STORMWATER DRAIN #417 to serve BROOKFIELD ADDITION - PHASE I CITY OF WICHITA, KANSAS

Gary Janzen, P.E. City Engineer
Project Number 468 - 85177
OCA Number 751555

AS BUILT PLANS

Contractor: Unruh Excavating
Inspector: David VanSickle, Baughman Co.
As Builts by: KEK, 2/21/18

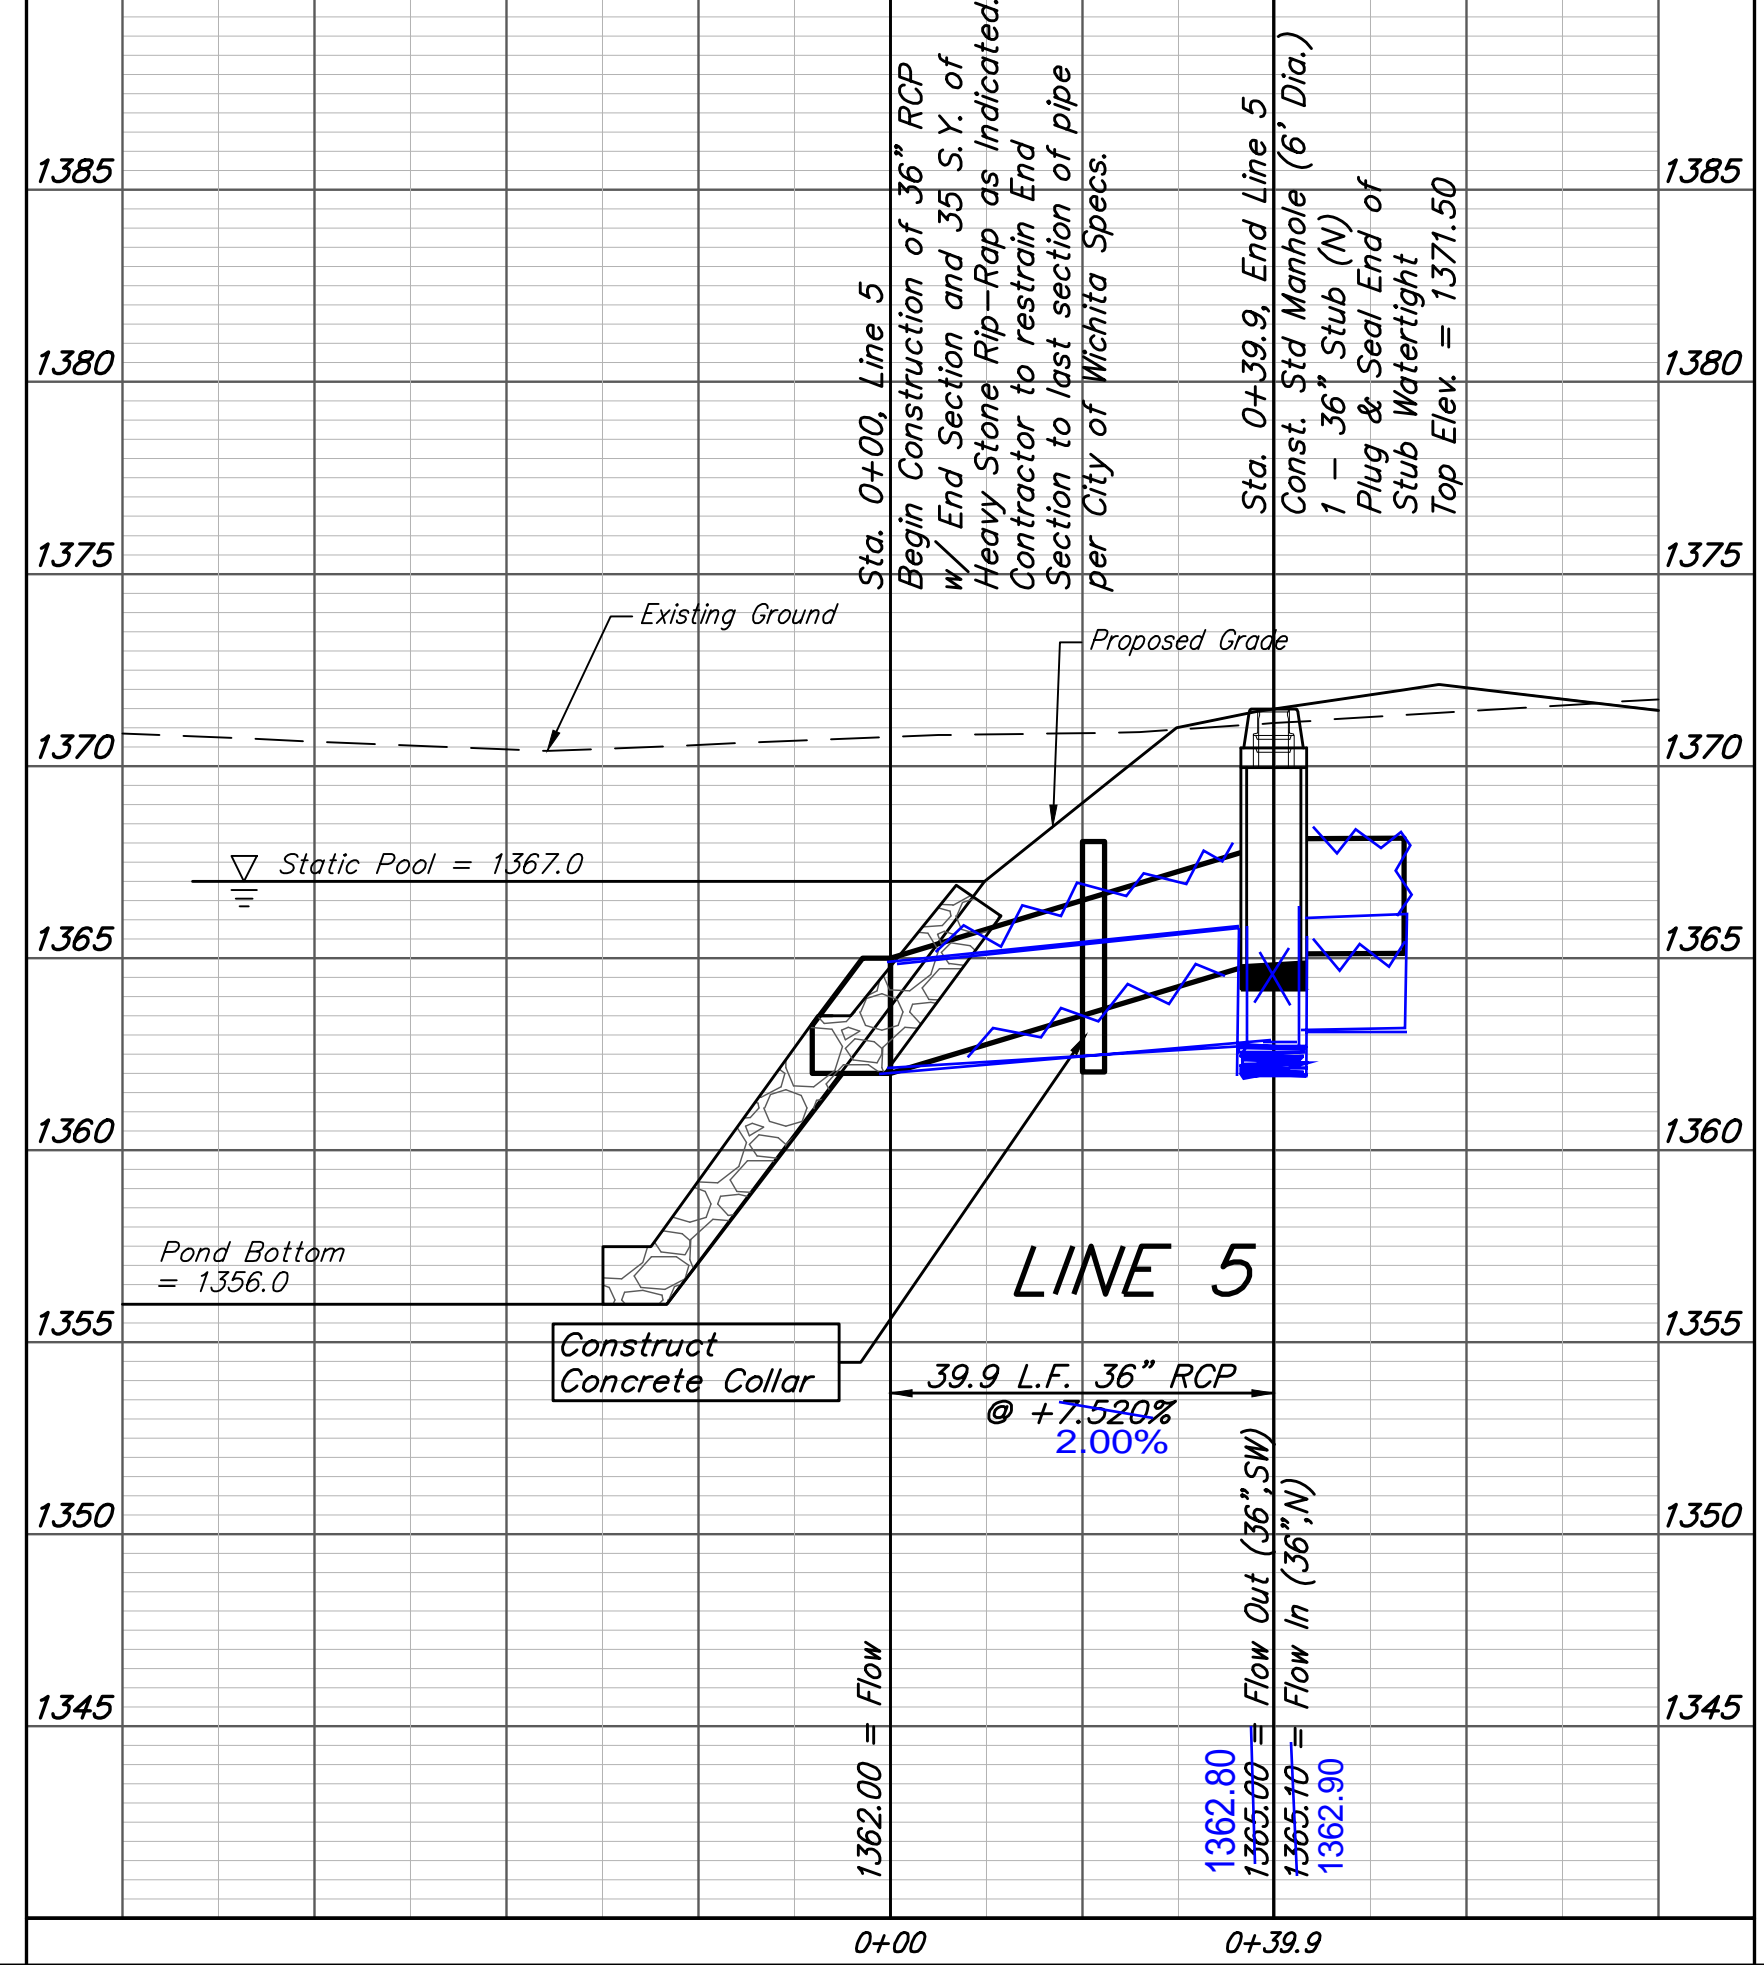
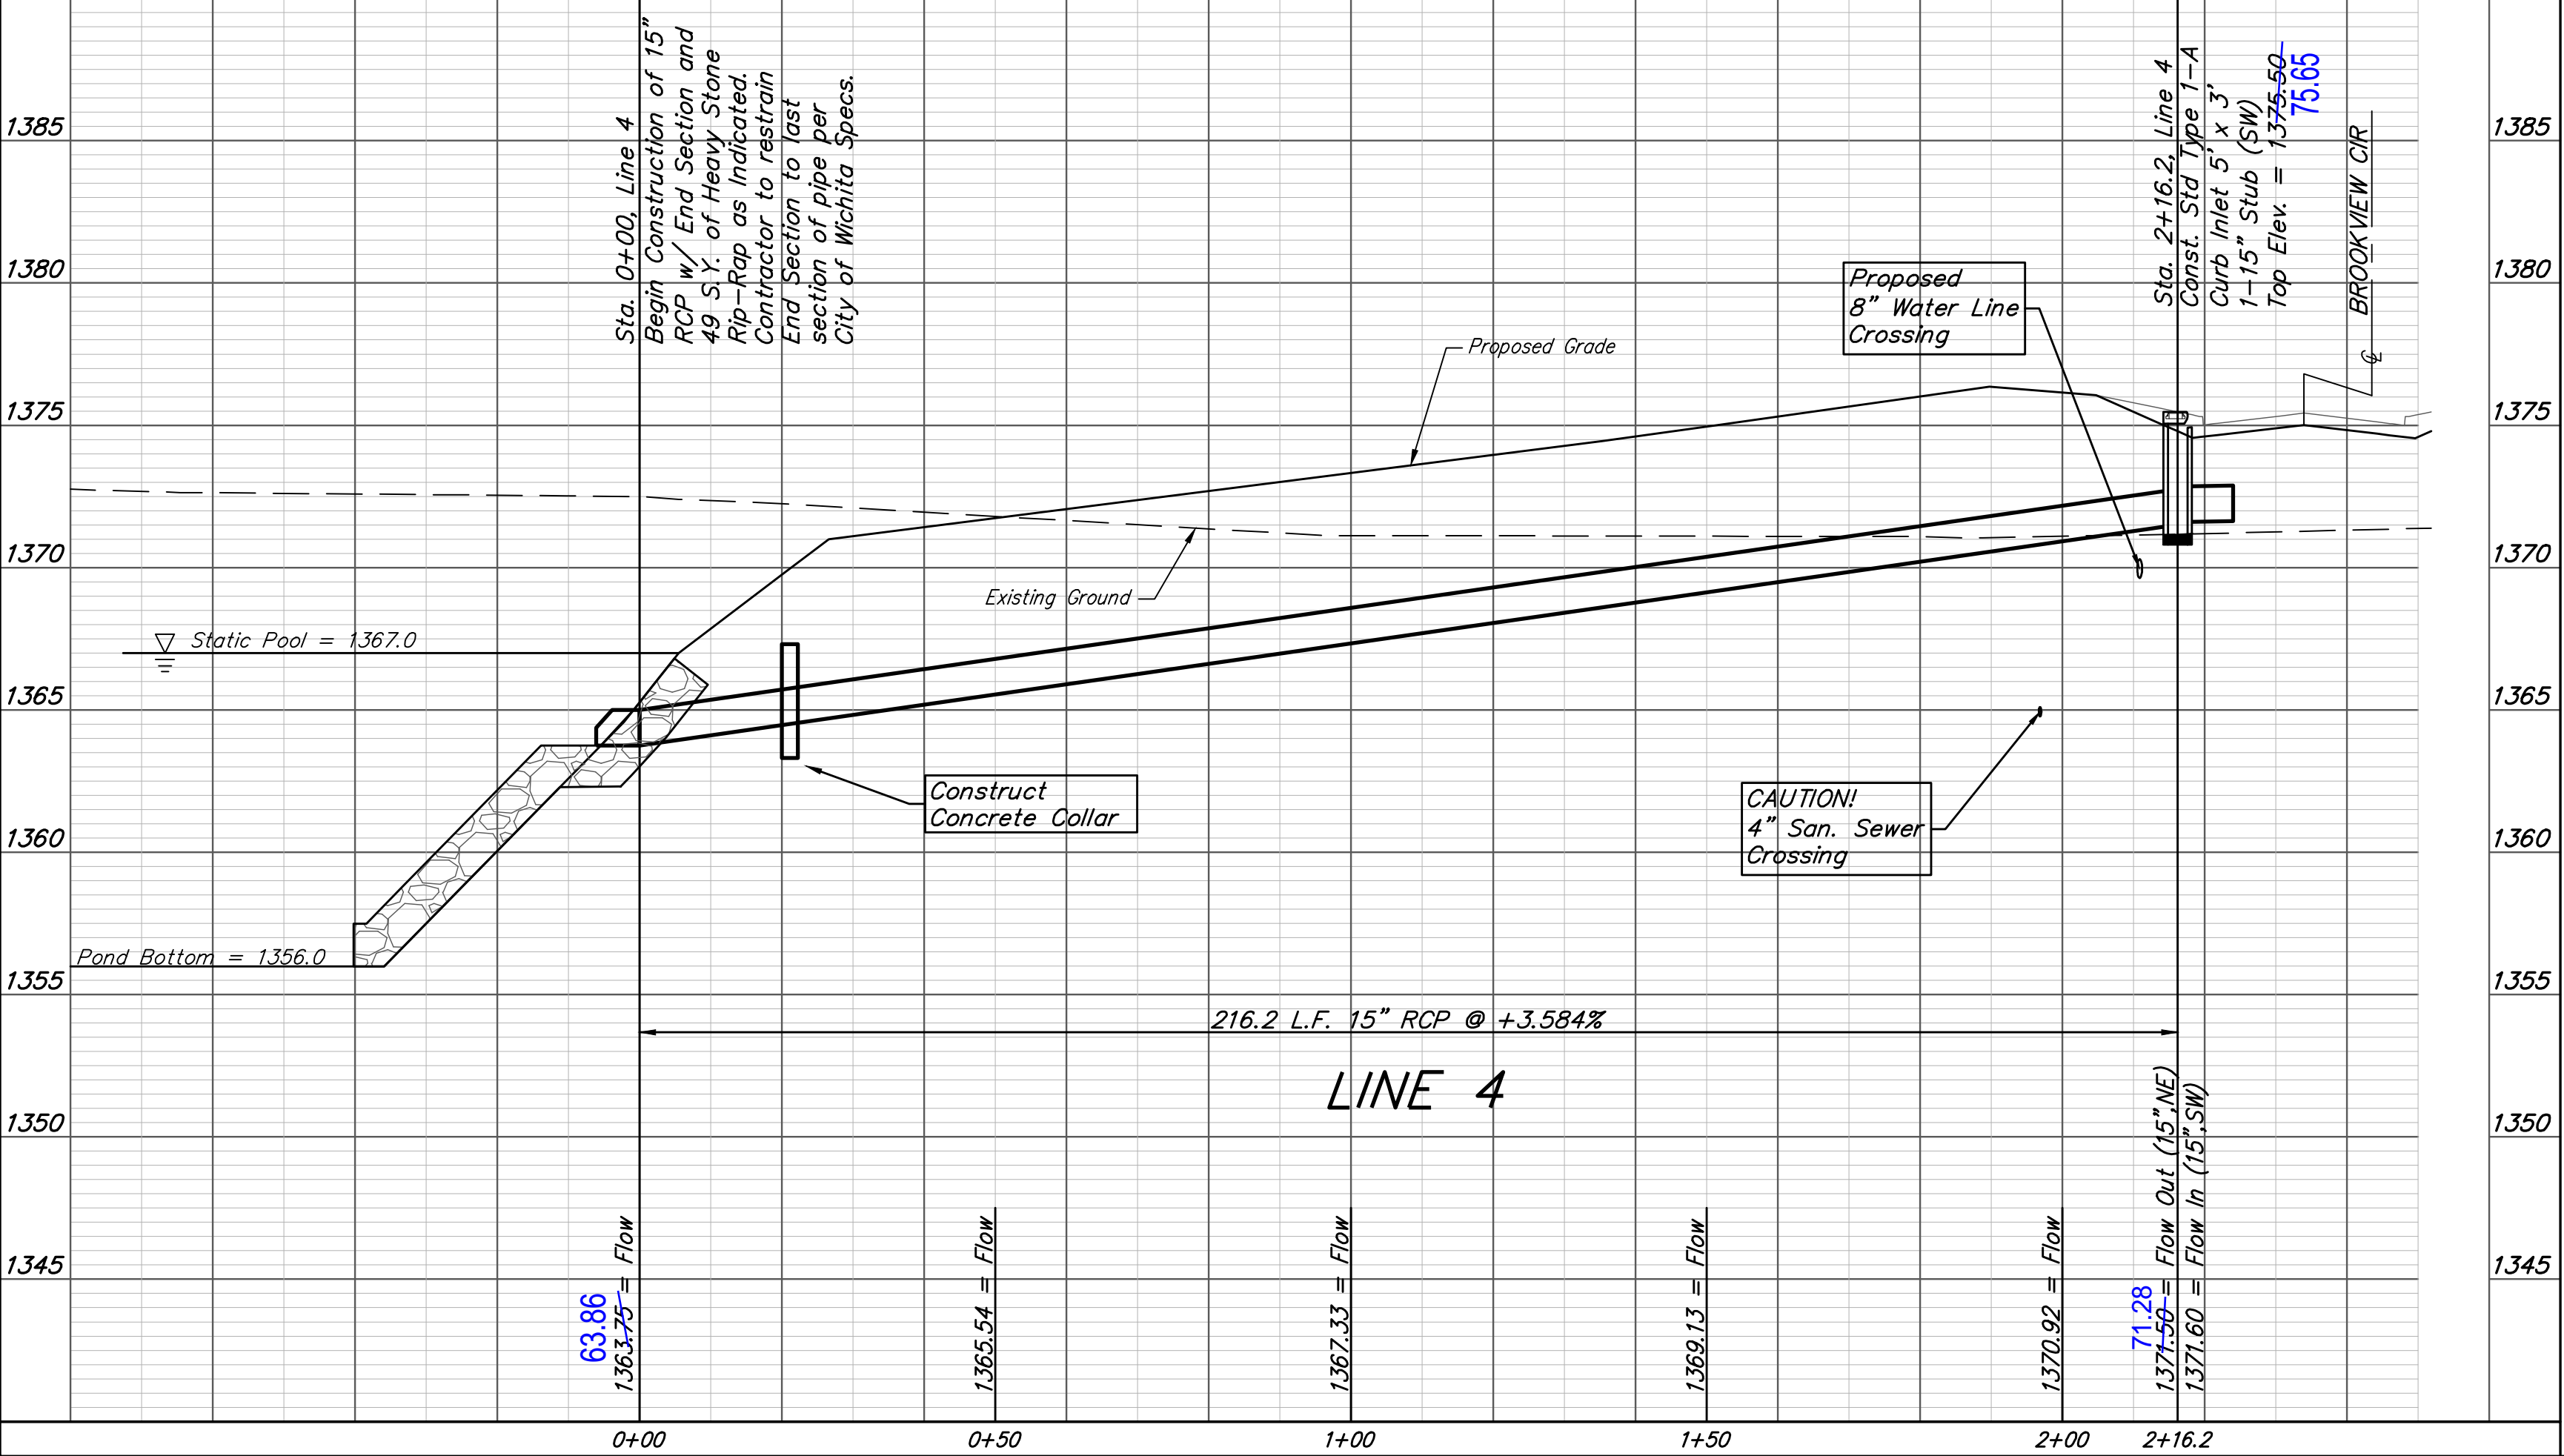
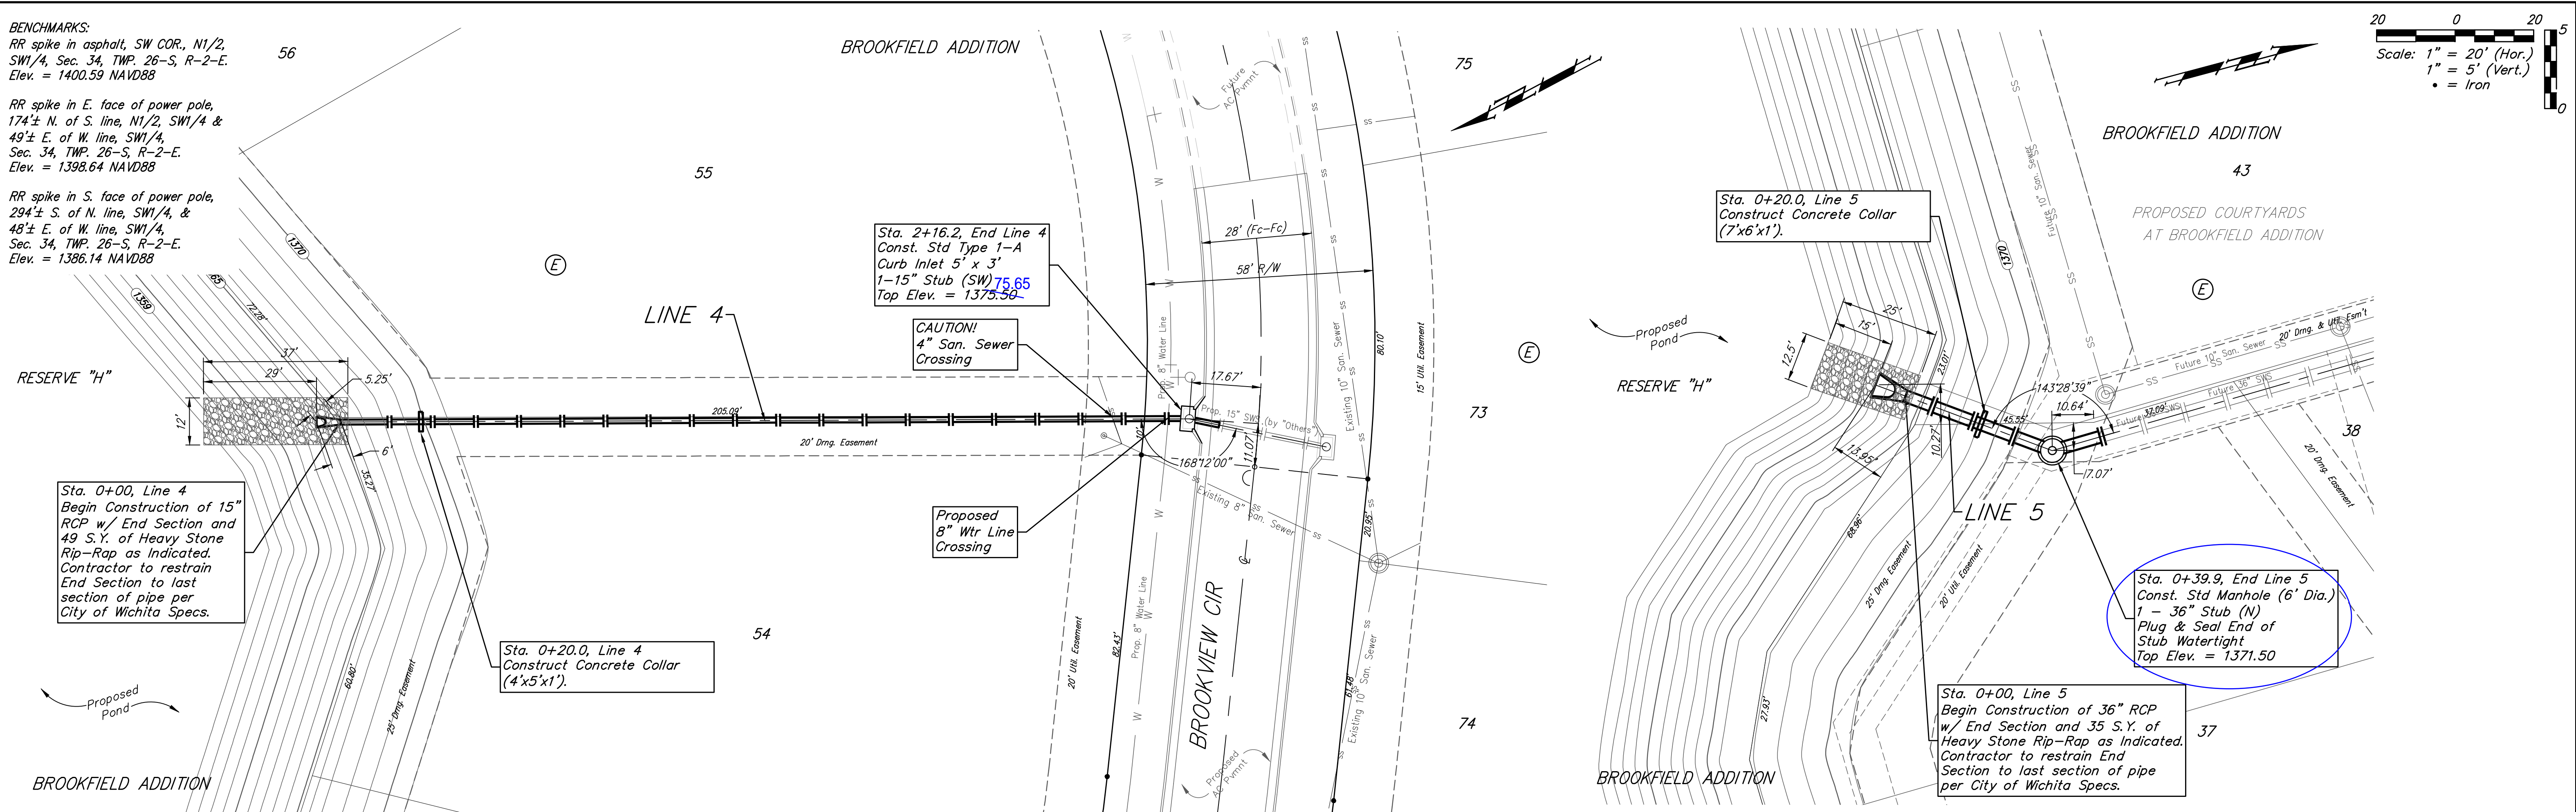
Sta 0+39.9 - Add 2'-2" barrel section to manhole to account for revised flow lines for 6' diameter manhole.
